U. S. NUCLEAR REGULATORY COMMISSION
REGION I

Report No. 86-05
Docket No. 50-271 License No. DPR-28
Licensee: Vermont Yankee Nuclear Power Corporation
RD 5, Box 169, Ferry Road
Brattleboro, Vermont 05301
Facility: Vermont Yankee Nuclear Power Station
Location: Vernon, Vermont
Dates: February 9-27, 1986
Inspectors: William J. Raymond, Senior Resident Inspector
Glenn W. Meyer, Project Engineer

Inspection Summary: Inspection on February 9-27, 1986 (Report No. 50-271/86-05)

Figure 1

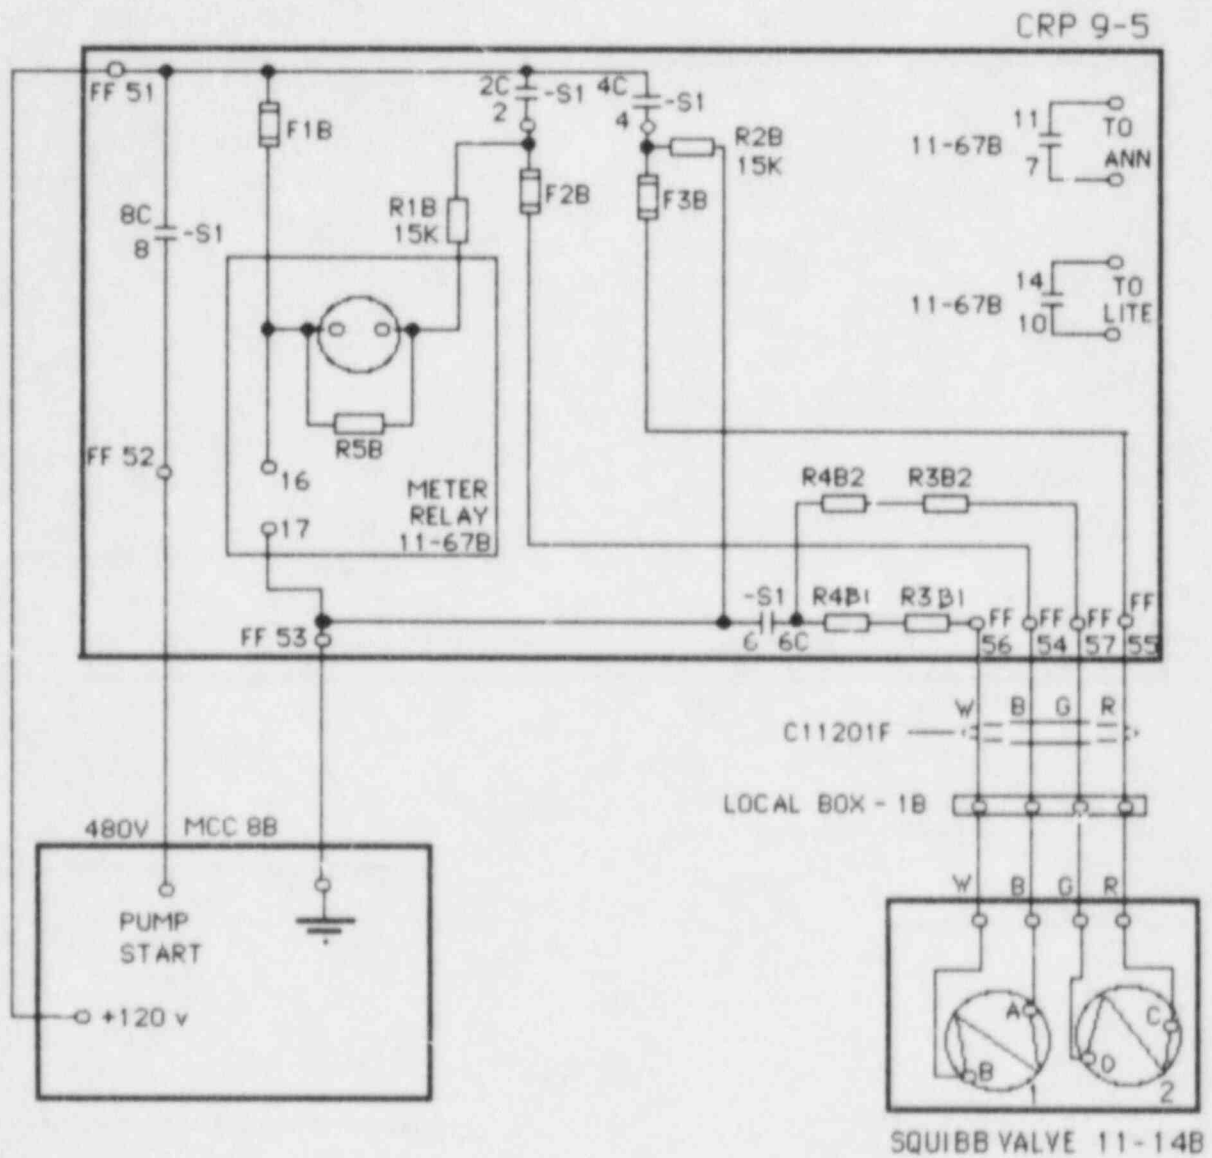
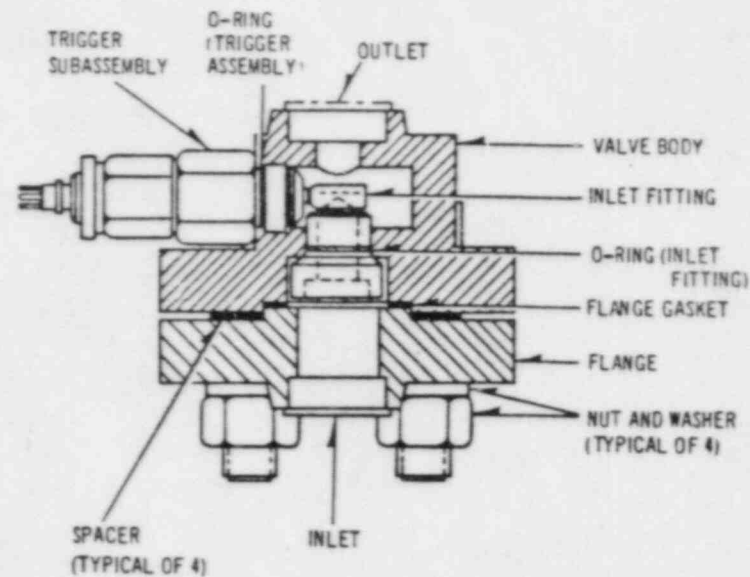
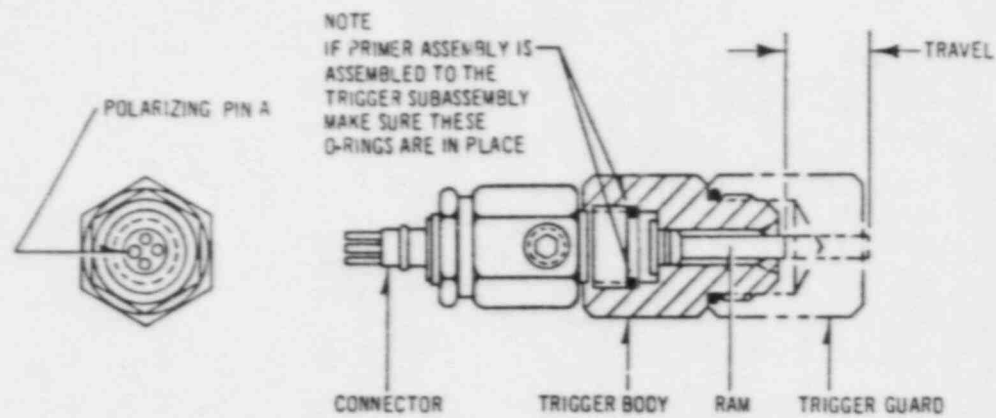
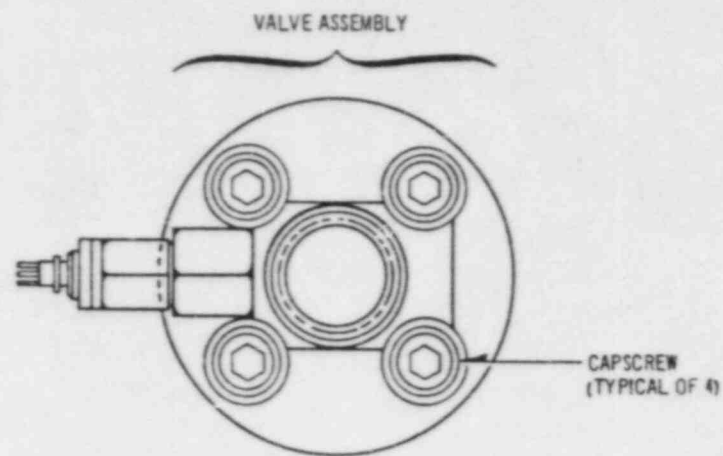
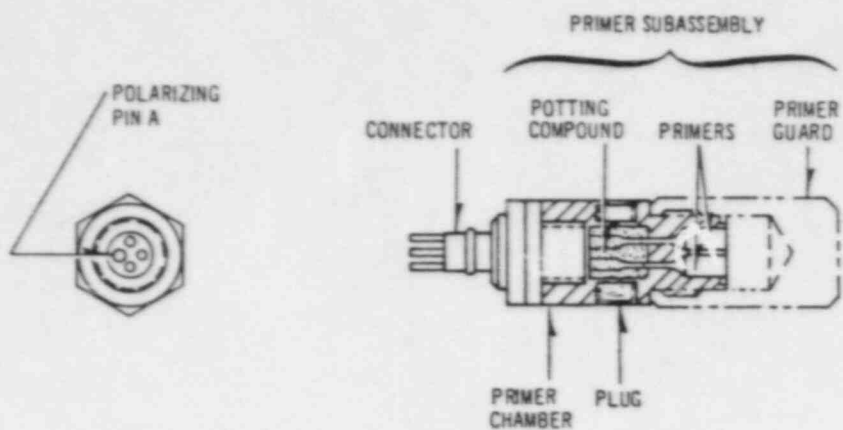
The continuity monitoring circuit, mentioned above, continuously confirms that the fuses, resistors, wires and bridgewires in each firing circuit are intact and lights a panel 9-5 light for each valve to confirm this. It does this by closing a contact in series with the panel light when control relay 11-67B is energized (picked up). The relay is normally energized when 120 VAC is supplied to one side of the coil, and a path to ground exists through the following circuit: 15K resistor R1B, fuse F2B, primer bridgewire AB, resistors R3B1-R4B1-R4B2-R3B2, primer bridgewire CD, fuse F3B, 15K resistor R2B, and neutral (see Figure 1).

The monitoring circuit indicated continuity existed, even though it would not fire because the following closed circuit existed (shown for "B" side - typical for both; see Figure 1): 120 VAC was provided through fuse F1B to one side of the coil for relay 11-67B; a path to ground existed through resistor R1B, F2A, terminal point FF 54, primer coil BA, terminal point FF 55, fuse F3B, resistor R2B, terminal point FF 53, and to neutral. Only one primer bridgewire was included in the monitoring circuit, instead of two for each squib valve, as is normally the case.

This item is significant because the configuration at Vermont Yankee is believed to be typical of the standard circuit design recommended by the vendor. This item will be reviewed further by the NRC to determine for generic applicability and appropriate followup actions (IFI 86-05-03).
